- 9. Thorsland Subdivision Addition No. 1; KPB File 2022-069  
Segesser Surveys / Evenson  
Location: Lake Marie Ave. & Holt Lamplight Rd.  
Nikiski Area**

ITEM 9 - THORSLAND SUBDIVISION ADDITION NO 1

<b>KPB File No.</b>	2022-069
<b>Plat Committee Meeting:</b>	June 13, 2022
<b>Applicant / Owner:</b>	Evenson Estate of Anchorage, AK
<b>Surveyor:</b>	John Segesser / Segesser Surveys
<b>General Location:</b>	Holt Lamplight Road, Lake Marie Avenue, Nikiski

Surveyor <b>Segesser Surveys</b> 30485 Rosland St. Soldotna, AK 99669 (907) 262-3909	Owner <b>James L. &amp; Nedra T. Evenson</b> 4140 Folker St., Apt 205 Anchorage, AK 99508
JOB NO. 21358	DRAWN: 5-19-22
SURVEYED: Nov., 2021	SCALE: 1"=200'
FIELD BOOK: 21-6	SHEET: 1 of 2

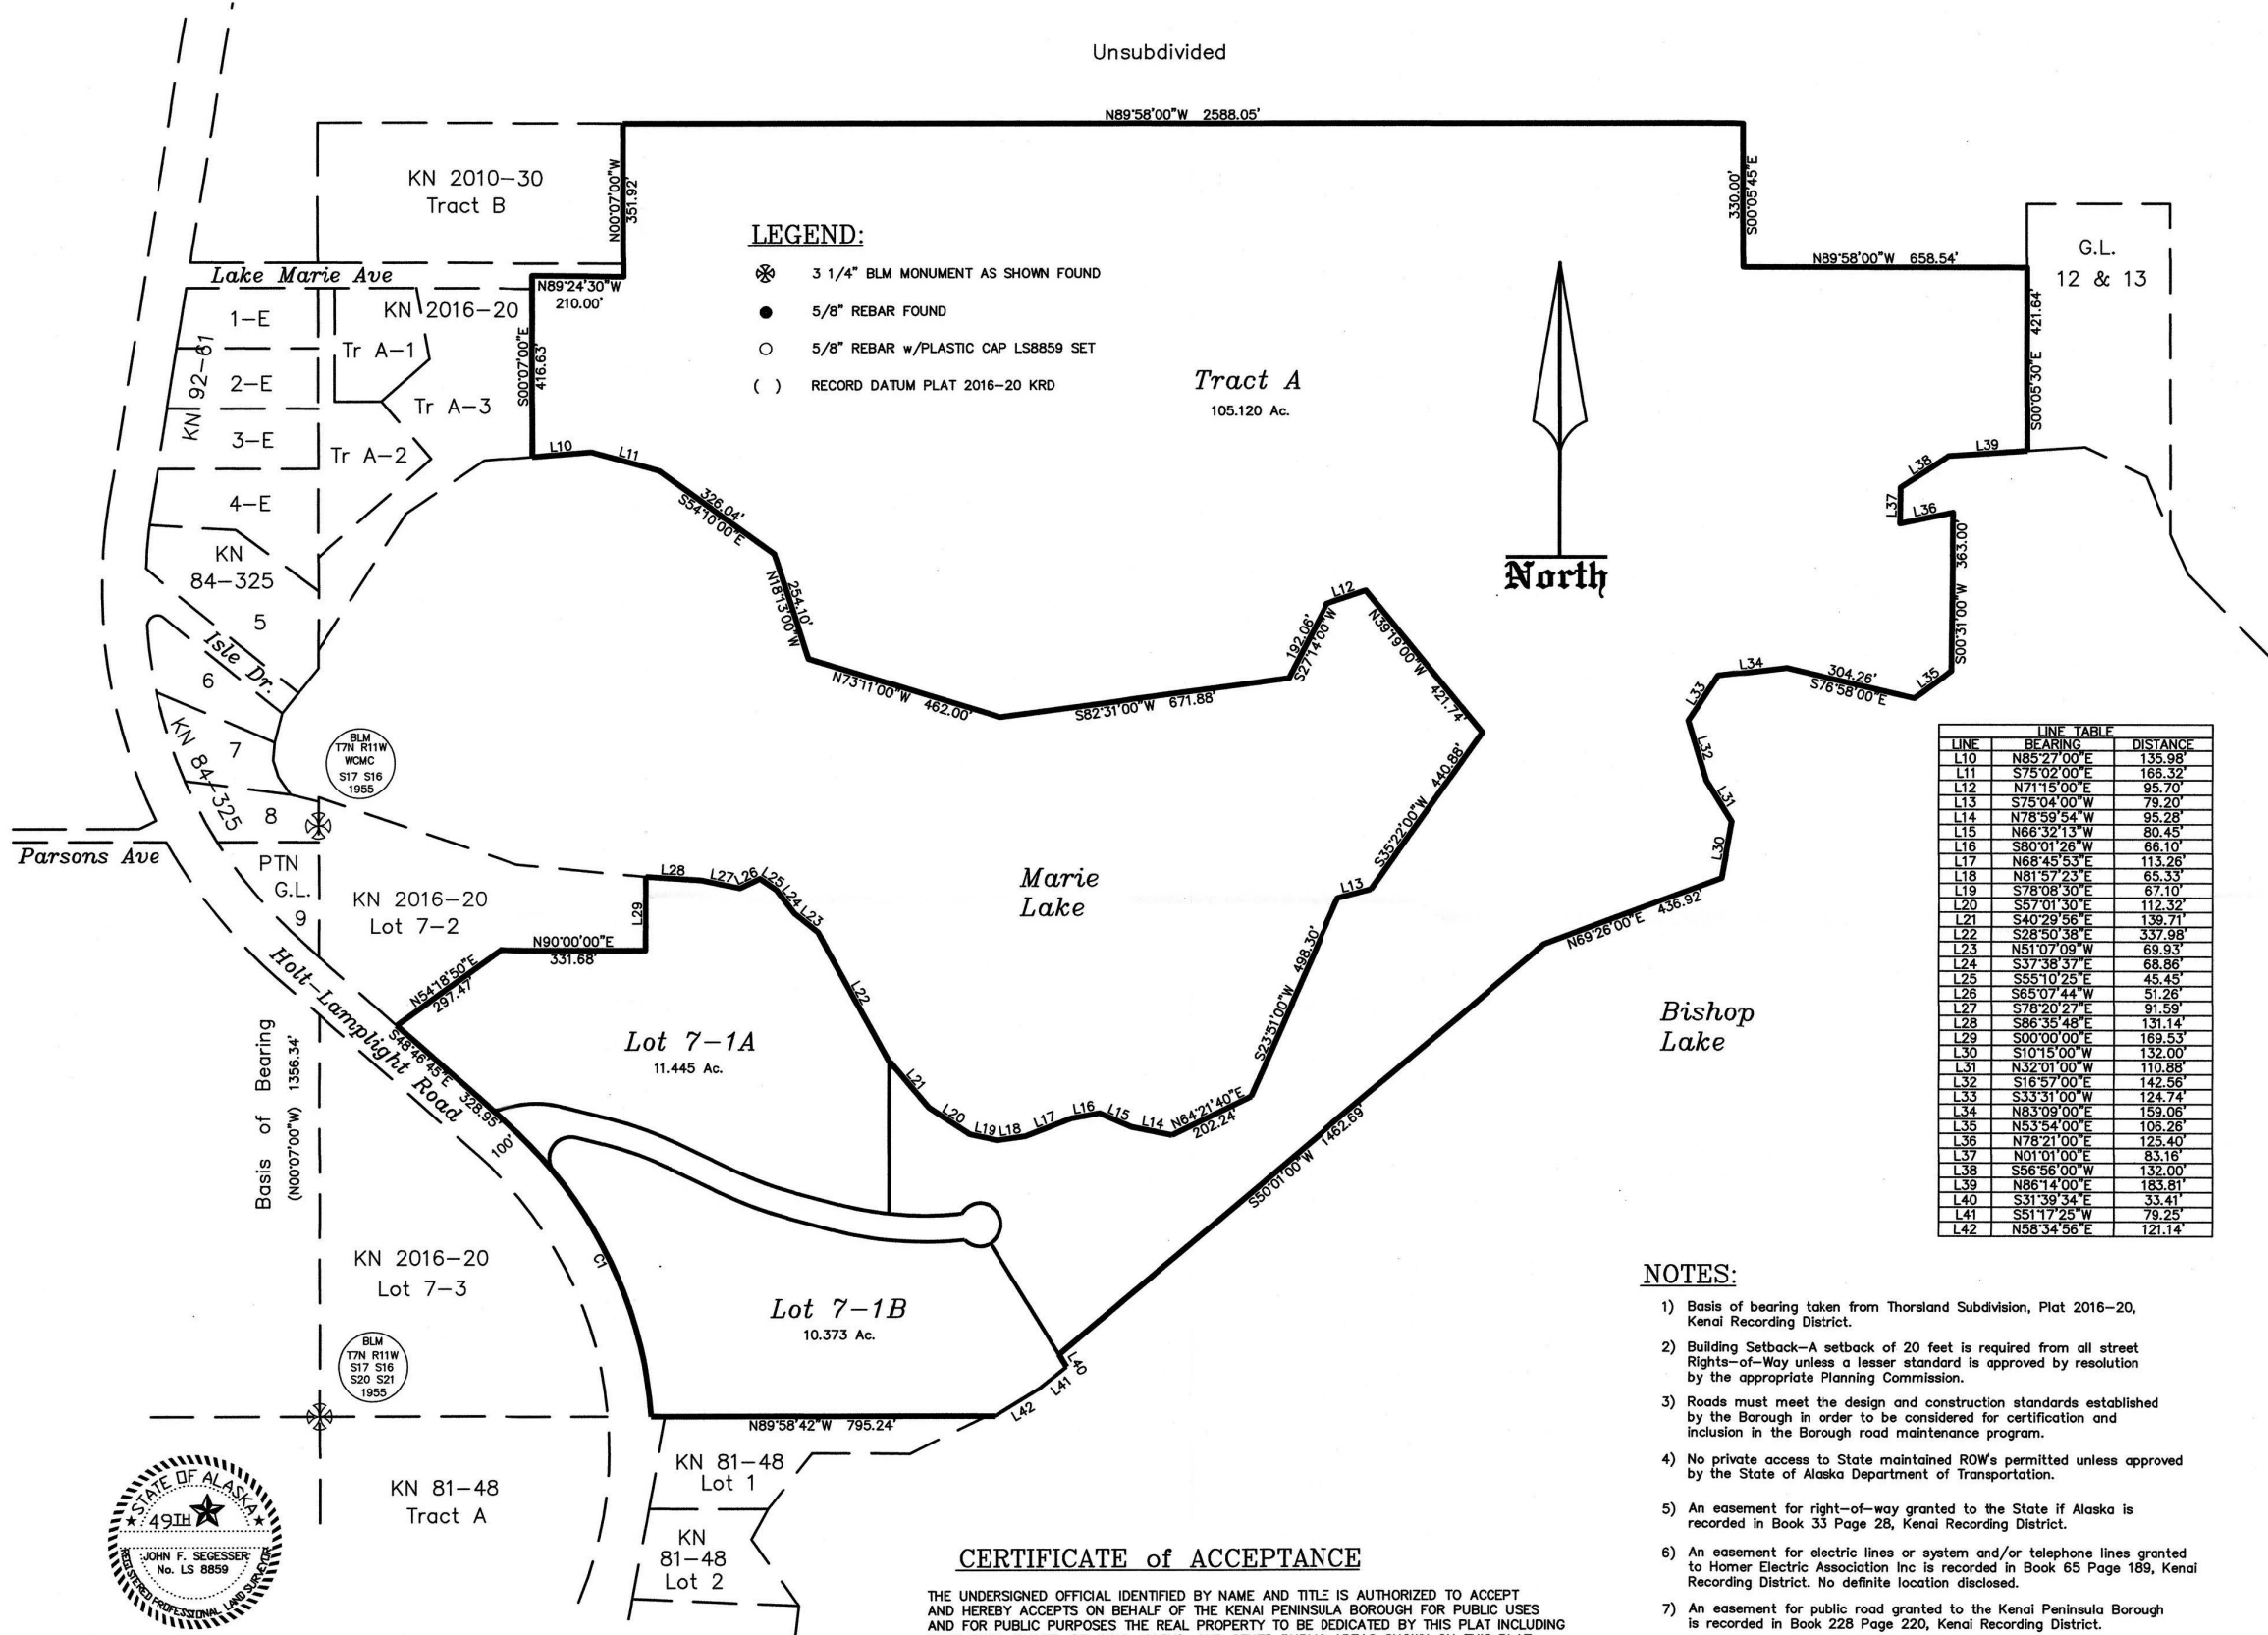
The proposed cul-de-sac appears to be proposed on an existing drive that provides access to an improvement that is located between Marie Lake and Bishop Lake. The proposed length of the cul-de-sac exceeds the length limits stated within KPB 20.30.100. The surveyor has discussed with staff that the dedication could be shortened to comply. **Staff recommends the length of the cul-de-sac be revised to comply with KPB Code unless an exception is requested and granted.**

The depiction of Lake Marie Avenue on sheet one appears to need revision. The current depiction indicates that the right-of-way narrows to 30 feet that is only dedicated on the northern side of the right-of-way. Senior Shore Addition Number 2, Plat KN 2010-30, created Tract B to the north and also dedicated a full 60 foot wide right of way from the eastern edge of Tract A-3 to the eastern edge of Tract B. **Staff recommends the depiction of Lake Marie Avenue be revised to show existing dedications.**

- Staff recommendation:** *Provide width labels for Lake Marie Avenue and Isle Drive on sheet 1. Provide a label for Holt Lamplight Road that includes the plat number for the right-of-way information, Plat KN 85-44. Remove the hyphen from Holt Lamplight labels.*

- Staff recommendation:** *Shaded "this plat" is not shown in vicinity.*
- F. The location, width and name of existing and platted streets and public ways, railroad rights-of-way, easements, and travel ways existing and proposed, within the subdivision;

**Staff recommendation:** The proposed dedication is atop a private road that had been named Evenson Drive. Include the name for the new dedication on both sheets and a width label is needed on sheet 1.

**Staff recommendation:** Sheet 1 – The lots adjacent to Holt Lamplight Road along the east have block designations that should be added, update the recording number for Tract A-3 that is adjacent to the plat, provide a label width for Parsons Avenue, review the depiction of the Parsons Avenue intersection and update as needed, revised the depiction for the lot south of Parsons Avenue as this appears to be two lots in that area and both will need labels.

JOB NO. 21358	DRAWN: 5-19-22
SURVEYED: Nov., 2021	SCALE: 1"=100'
FIELD BOOK: 21-6	SHEET: 2 of 2

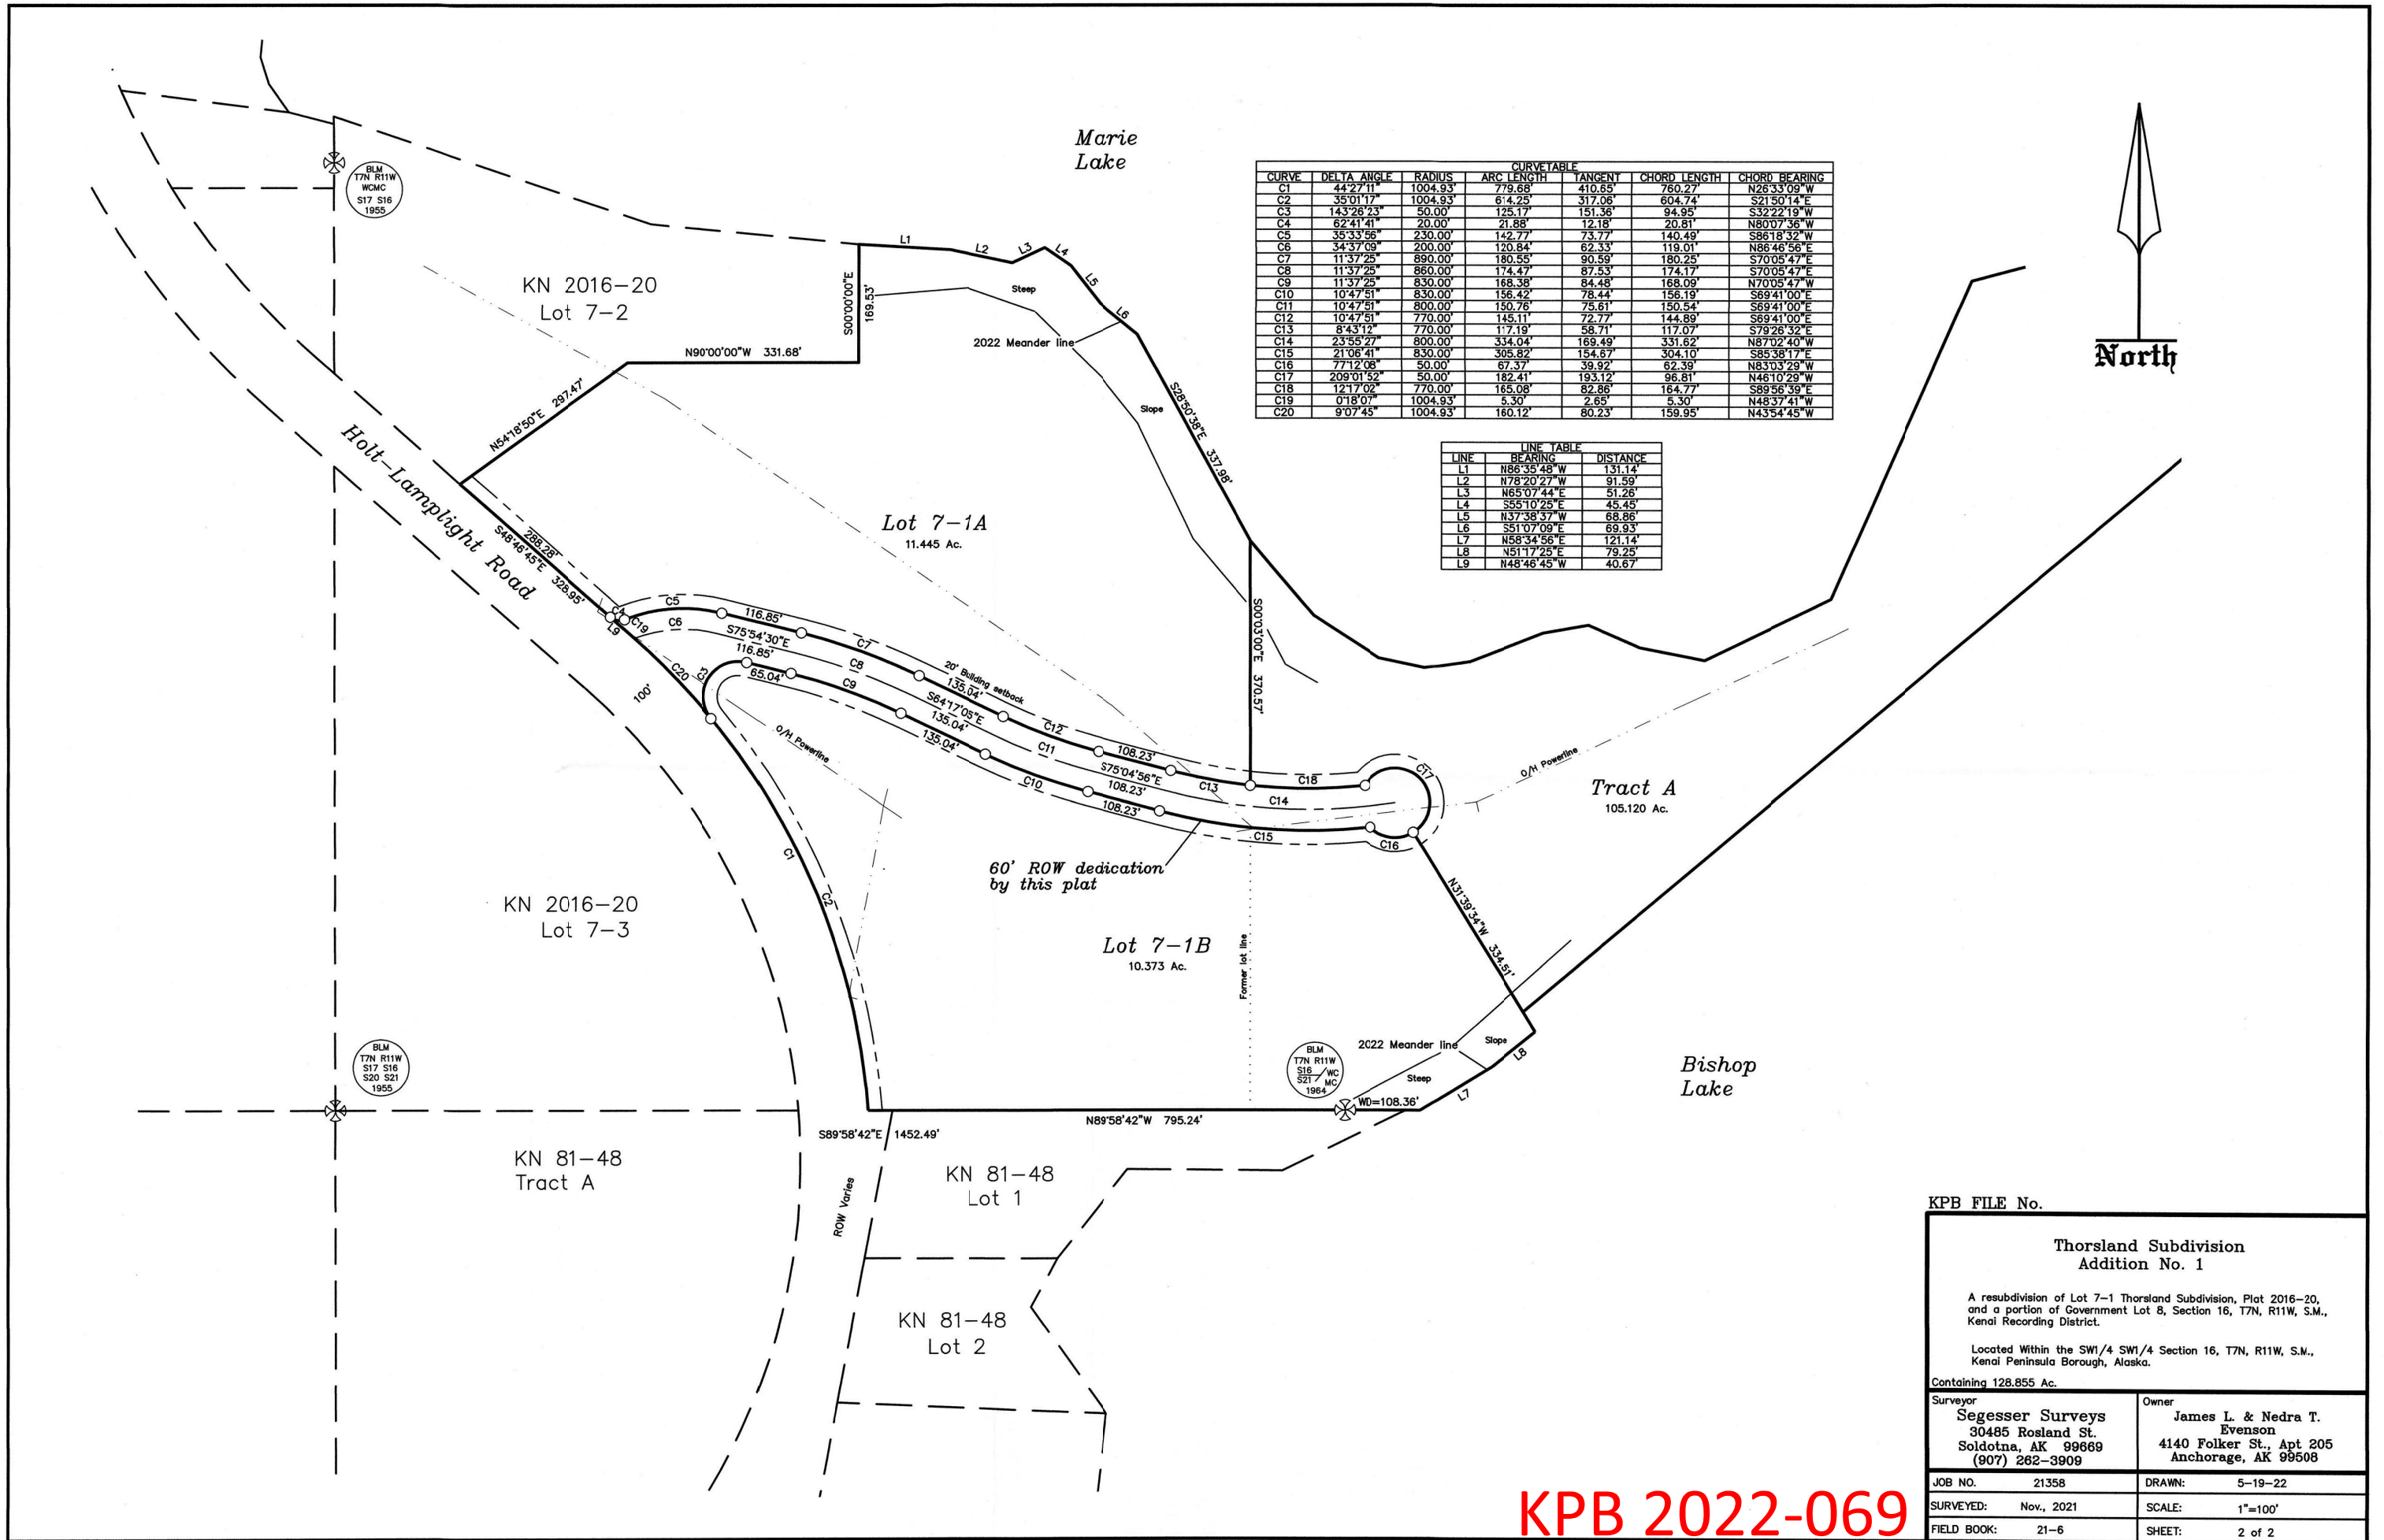
The parent Lot 7-1 had some easements granted with the recording of Thorsland Subdivision, Plat KN 2016-20. The parent plat granted 15 foot utility easements along Holt Lamplight Road. **Staff recommends** sheet two depict the 15 foot utility easements and provide a note stating they were "granted per KN 2016-20."

Sheet 2 – Update the depiction of the lots across Holt Lamplight Road and provide labels, and add labels for the lots adjacent to Lot 7-2.
